14 October 2011  
Ref: J1985L\_3

**QUEENSLAND FLOODS COMMISSION OF INQUIRY  
REVIEW OF ASPECTS OF THE REPORT OF WMAWATER (SEPT 2011)**

Figure 3: Port Office- Pre and Post dam flow

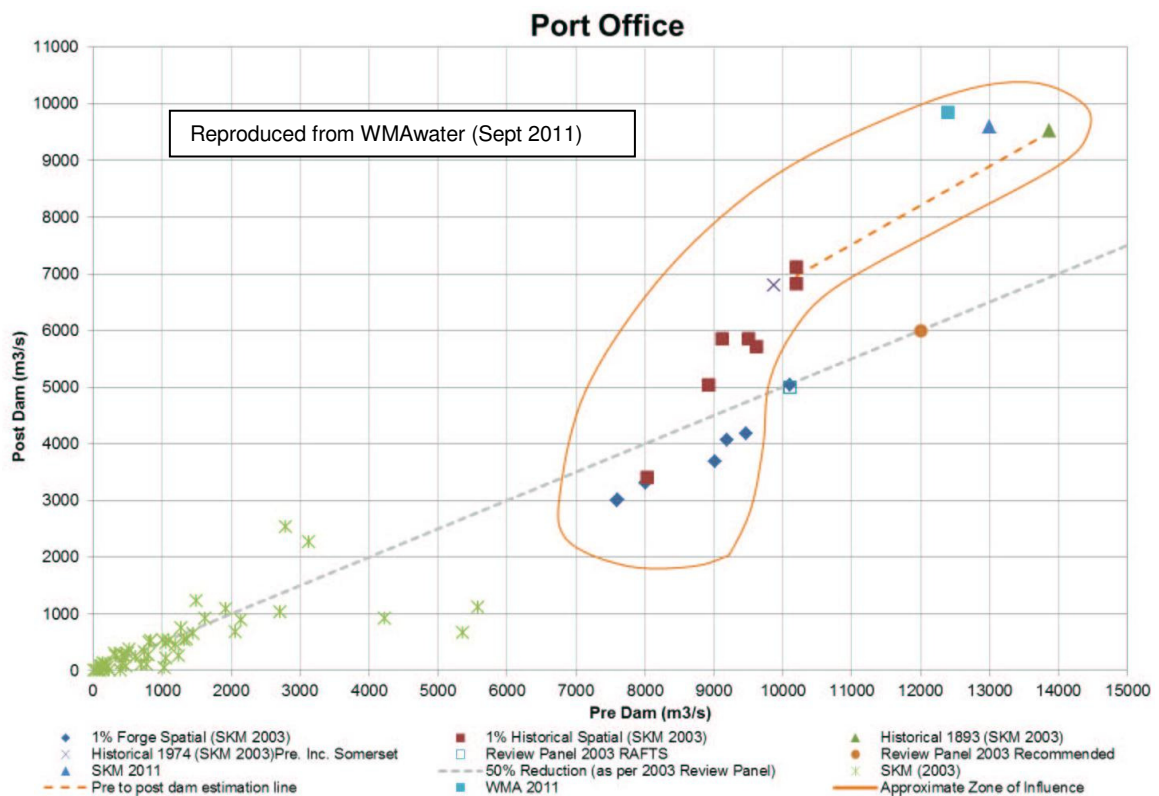
**Review the appropriateness of Figure 3 (page 15, WMAwater report) and the use to which it has been put within the report.**

11. Figure 3 contains a "pre to post dam estimation line" prepared by WMAwater. A copy of Figure 3 has been reproduced below.

12. This estimation line was used by WMAwater to convert their pre-dams 1% AEP discharge estimate of 13,000m<sup>3</sup>/s to a post-dams discharge of 9,000m<sup>3</sup>/s (without the influence of the 2011 event). It was also used (together with 2011 flood data) to estimate the post-dams discharge of 9,500m<sup>3</sup>/s (assuming knowledge of the 2011 flood). It is therefore a vital component of WMAwater's process for the determination of 1% AEP flows at the Port Office gauge.
13. The procedure used by WMAwater to prepare this line has not been explained in their report. The line appears to be either:

- (a) a line representing a 32% reduction in pre-dam flows; and/or
  - (b) a line drawn between data for the 1893 flood and the highest two "1% Historical Spatial" data points.

14. The "*pre to post dam estimation line*" assumes a linear relationship between pre- and post-dams discharges. There will be a reduction in the amount of attenuation as the magnitude of flood discharges and volumes increases during major floods so a curve rather than a line is appropriate.

15. Some of "1% Historical Spatial" data on Figure 3 do not appear to be plotted in the correct position. The data likely originates from the "*critical flows*" presented in Appendix H of SKM (2003) for the seven historical spatial patterns considered by SKM. For some of the seven patterns however the data plotted are for different storm durations. Thus the pre-dam and post-dam discharges do not correspond to the same catchment event.

16. The "*Historical 1974*" data point included on the figure includes for the effects of Somerset Dam in the pre-dams discharge. WMAwater appear to be aware of this but it is unclear why it was included on the figure without first making an adjustment to remove the effects of Somerset Dam.

17. The probability of the "1% *FORGE Spatial*" data is known however the probability of the "1% *Historical Spatial*" data is not known. A difficulty arises in using such a diagram in the manner that WMAwater have used it because for a given pre-dam discharge, all of the data points do not have the same probability of occurrence.

18. There is considerable scatter in the data points on Figure 3. Floods come in all shapes and sizes. If all of them were plotted the scatter would likely be much wider than that shown. Floods that have more volume for a given pre-dam discharge will likely plot higher on the figure than those with a lower volume for the same discharge as these are subject to less attenuation by the dams. A range of attenuations is possible.

19. A key question is what attenuation amount from the range of possible attenuation amounts, should be used to attenuate the 1% AEP pre-dam discharge determined by WMAwater from their flood frequency analysis? This issue has not been explored by WMAwater.

20. In conclusion, assuming the pre-dam discharge has a probability of 1%, the post-dam discharge determined using the "*pre to post dam estimation line*" will likely have some bias away from a 1% AEP event.

Fig. 2: Flood height components for January 1974 at Brisbane City Gauge in metres above Australian Height Datum.

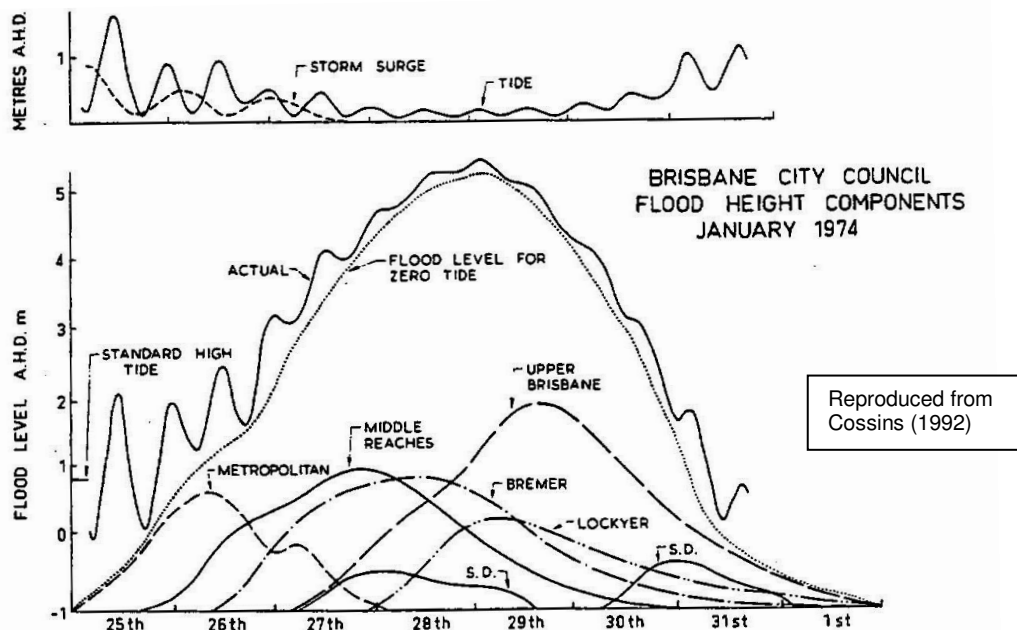
30. For example, when the flood height is say 1.5mAHD, at least  $\pm 0.5\text{m}$  or more could be due to normal tidal activity. Bigger ranges would likely occur if storm surges were present (as these often accompany floods) or spring tides. This tidal influence diminishes as the flood height rises but even at a flood level of 4mAHD, some tidal influence can be exerted.

31. The flood series used by WMAwater disregarded flows lower than  $2,000\text{m}^3/\text{s}$ .<sup>10</sup> From the 'derived rating' curve in their Figure 8, this flow corresponds to a level of 1.4mAHD. Very considerable tidal influences would likely be present at this level.

32. It is likely that about two thirds of the 30 floods used in their flood frequency analysis had peak heights less than 3mAHD at the Port Office gauge. The calculation of these flows based on the derived rating will therefore be sensitive or very sensitive to the influence of tides.

33. A rigorous analysis would see each of these events analysed to remove the effect of tides.<sup>11</sup> (This approach has been suggested in previous studies).
